Application No. 10/696,989

MICI 1001-2

**REMARKS**

Title: Self-Seeded Single-Frequency Solid-State Ring Laser, and Single-Frequency Laser  
 Peening Method and System Using Same  
 Application No. 10/696,989  
 Attorney Docket No. MICI 1001-2  
 ANNOTATED SHEET SHOWING CHANGES

FIG. 7

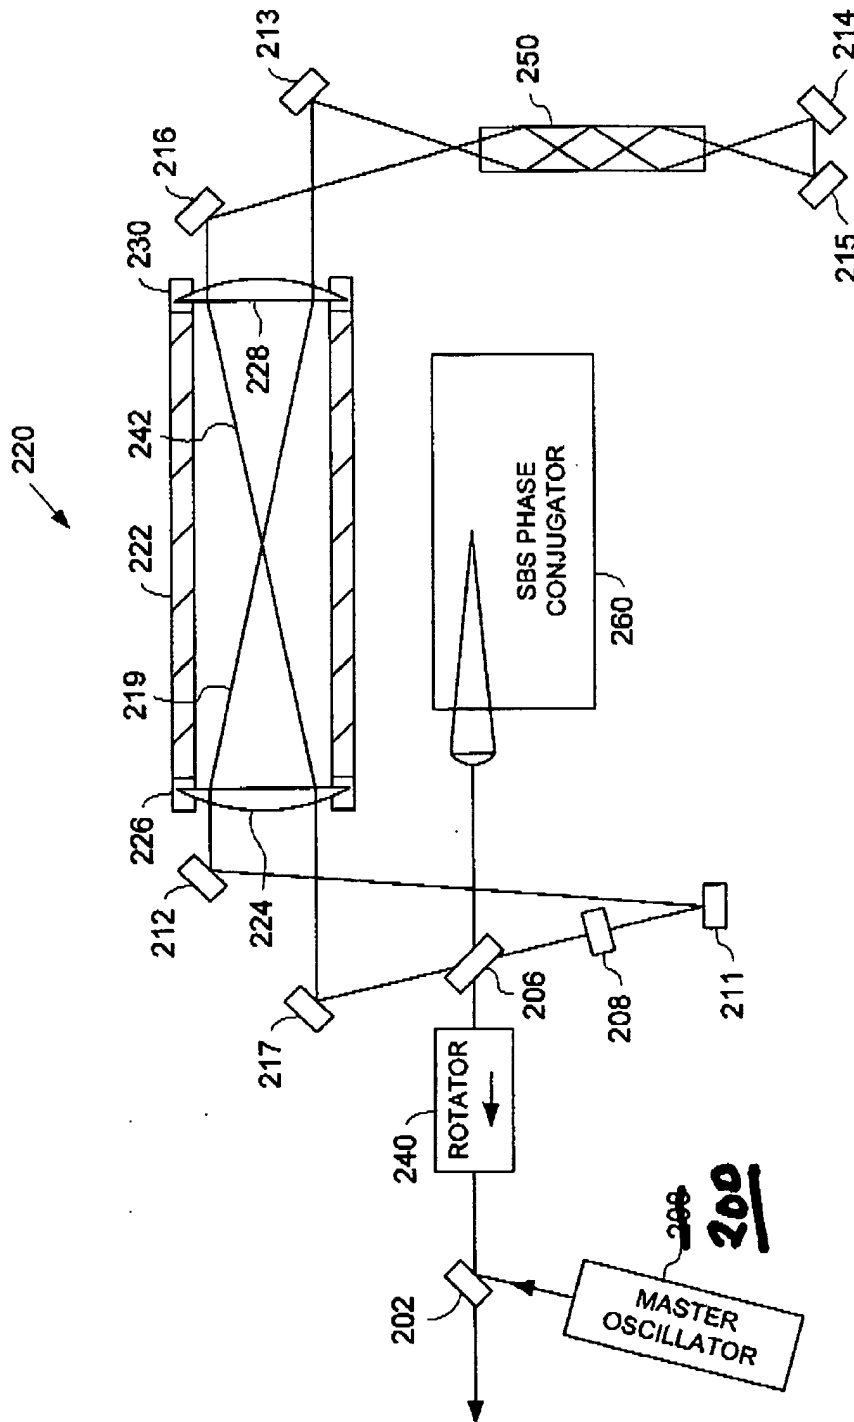
In addition, the Examiner has objected to the drawings because the reference numeral 200 used for the master oscillator in Fig. 7, is not found in the drawings. Rather the drawing mistakenly labels the master oscillator with the reference numeral 208. Applicant has submitted corrected Fig. 7 herewith to correct the mistake.

The attached sheet of drawings includes changes to Fig. 7. This sheet replaces the original sheet. In Fig. 7, element "208" has been amended to read -- 200 --.
